### Lunar Module (LM) Apollo Operations Handbook

**LMA790-3-LM 4**  
**APOLLO OPERATIONS HANDBOOK**

5.2.1 GUIDANCE, NAVIGATION, & CONTROL SUBSYSTEM

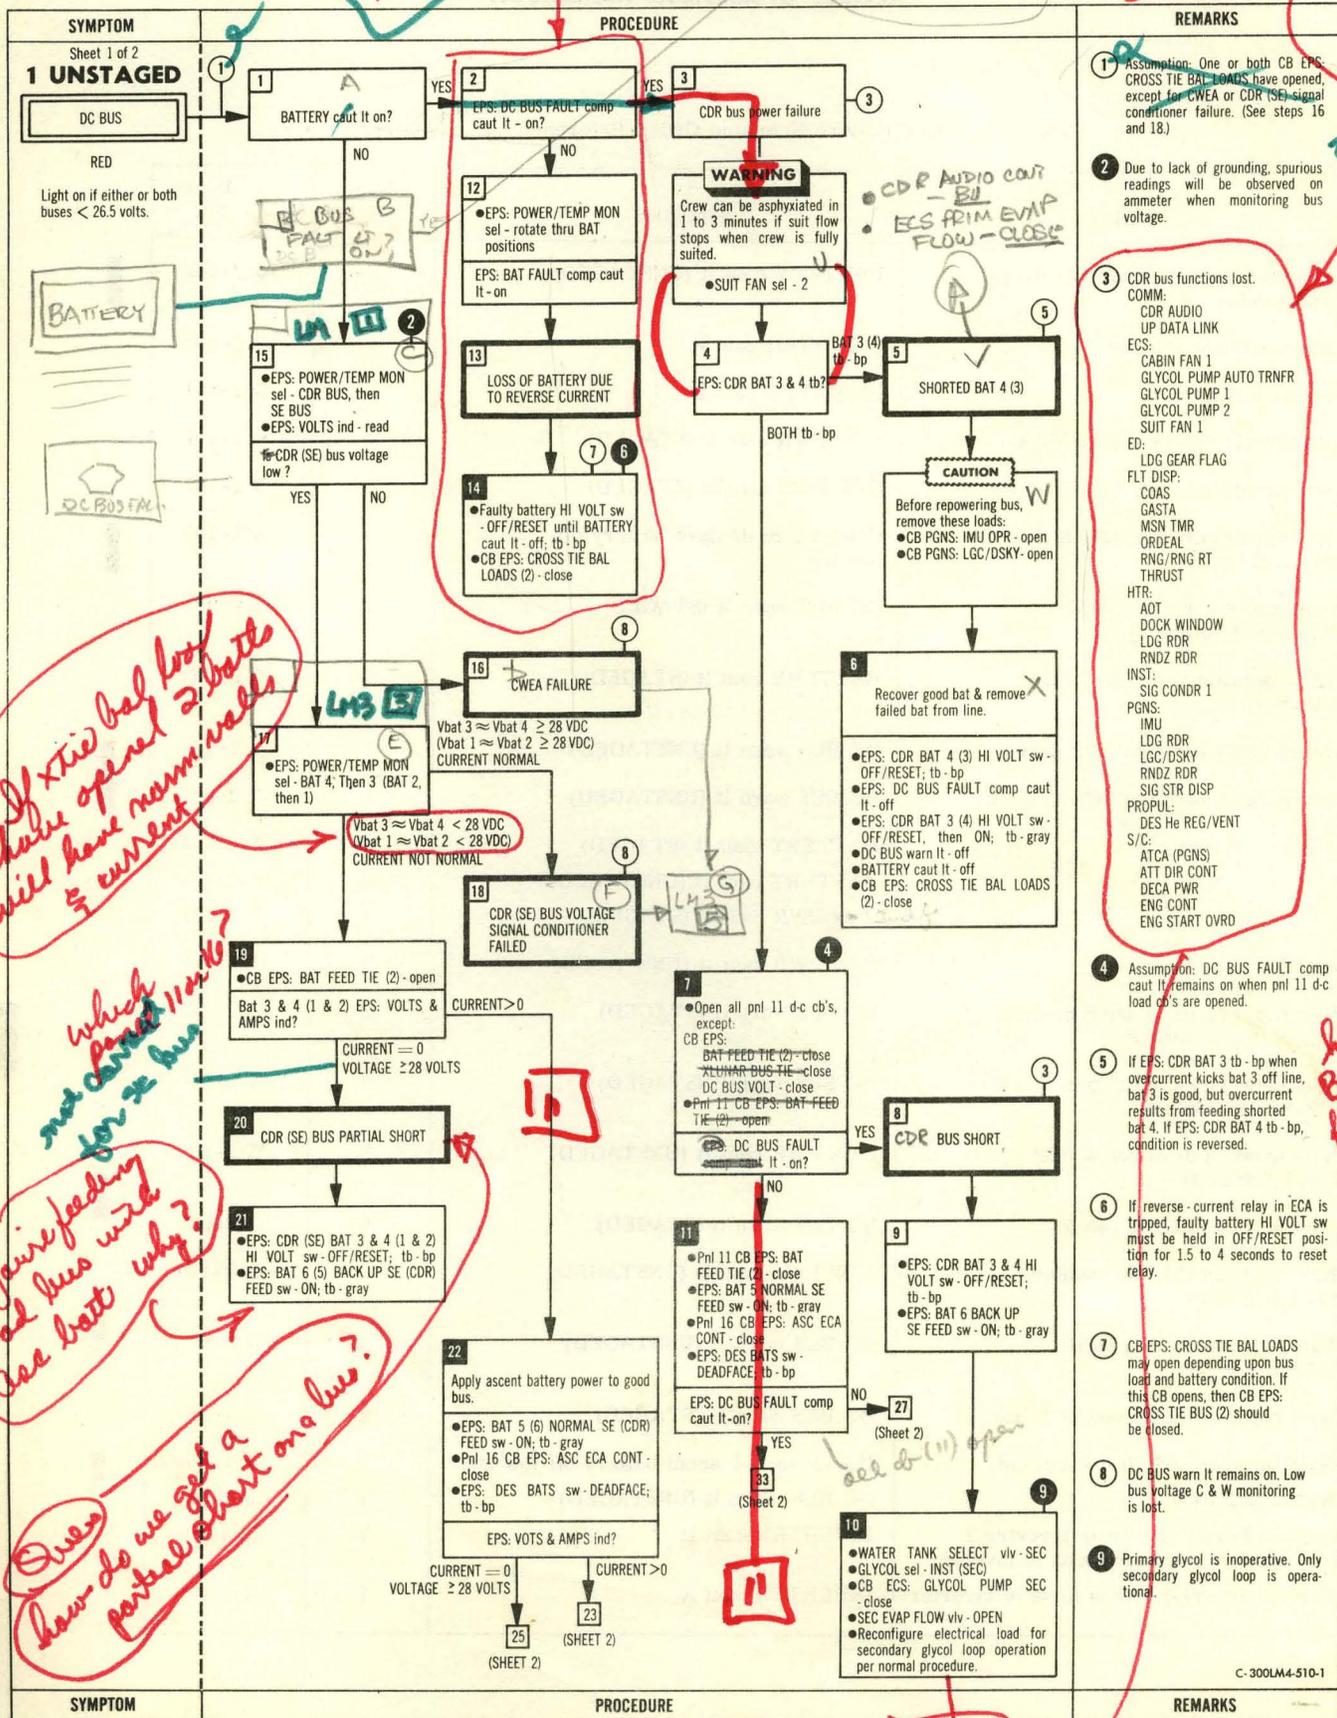
*IN BATT PWR LM3 drops slow out - why?*

*Use SSR for this since it is referred to many times in EPS section (See LM3)*

*If tie bal load have opened 2 batts will have normal voltage & current*

*which panel monitor? not correct monitor for 2 bus*

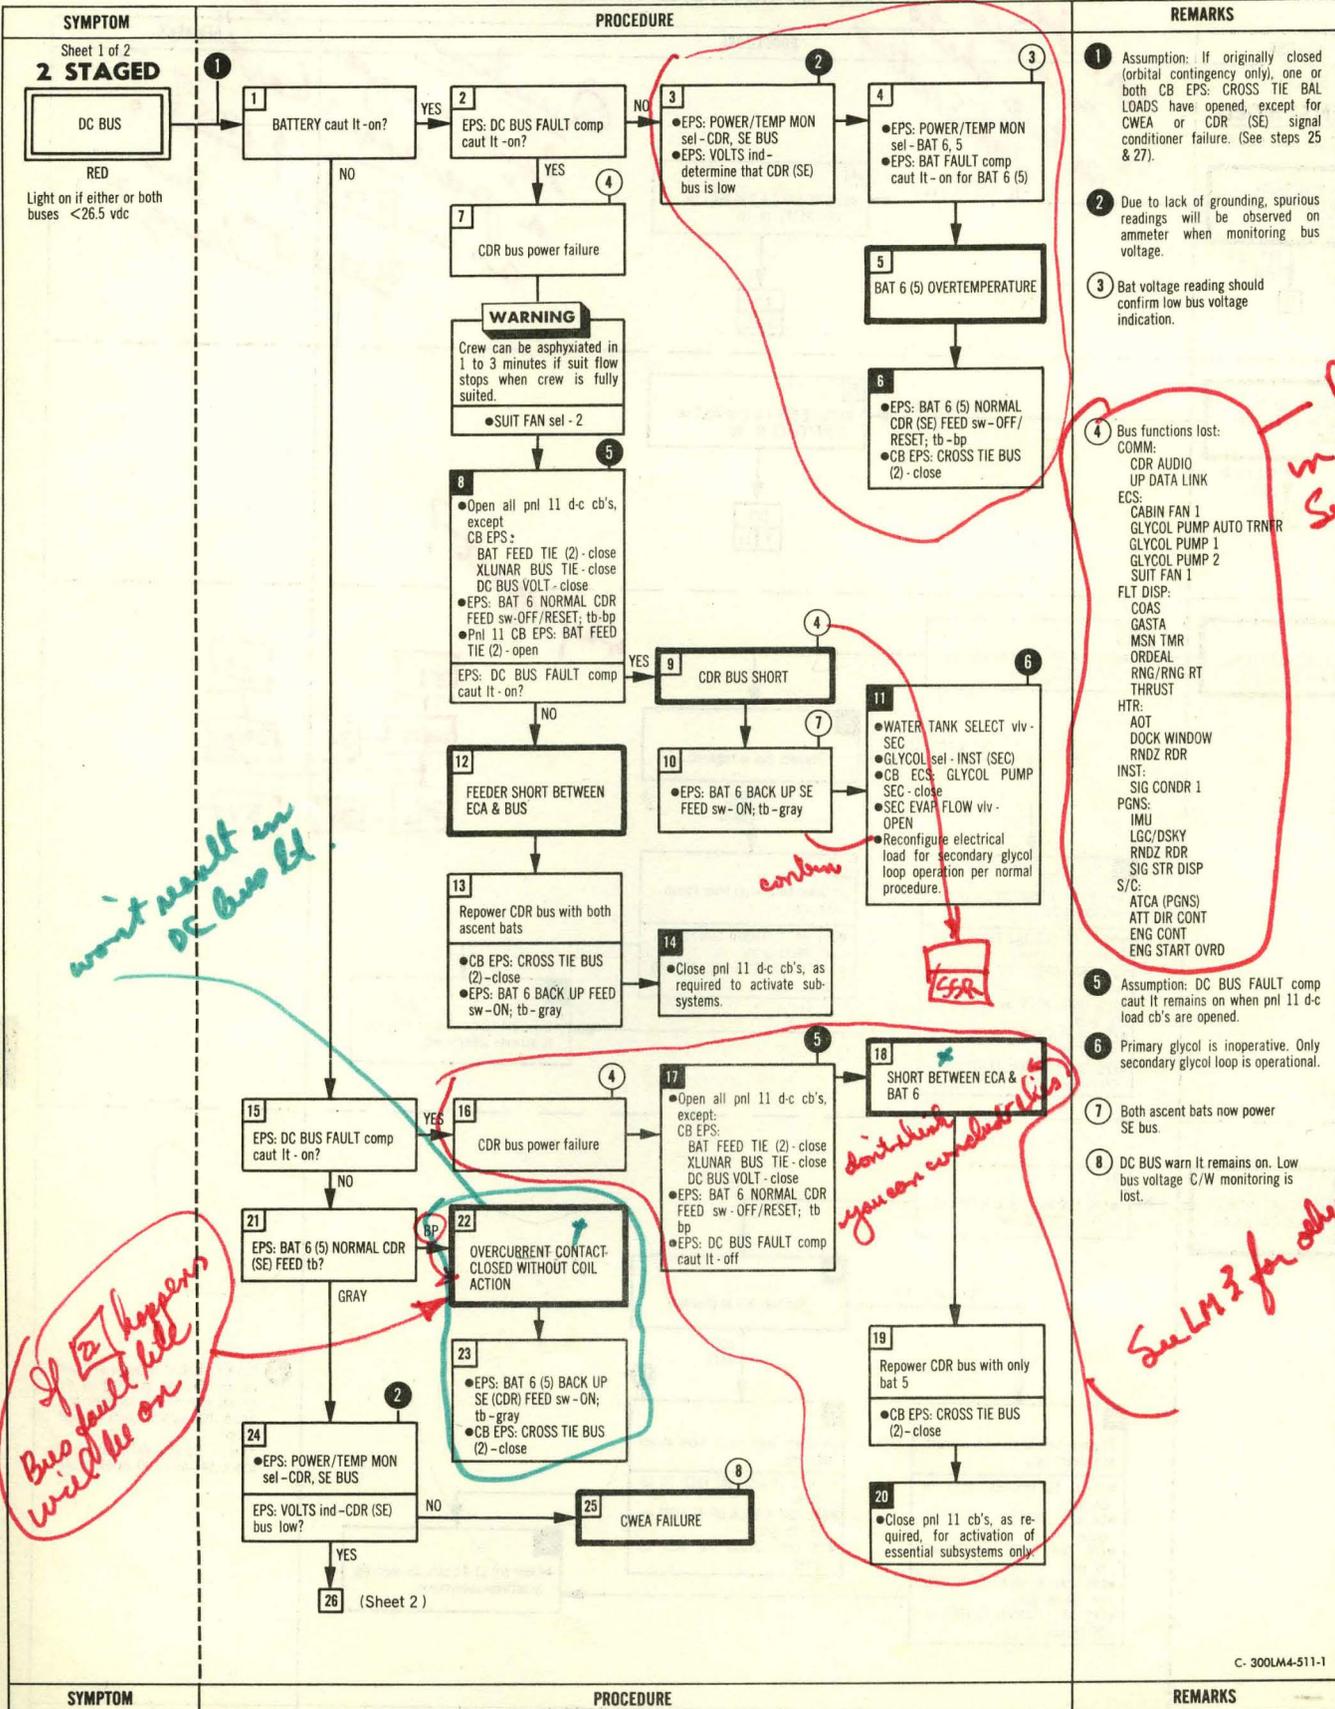
*LM 3 drops this out why?*

*won't result in DC bus bl*
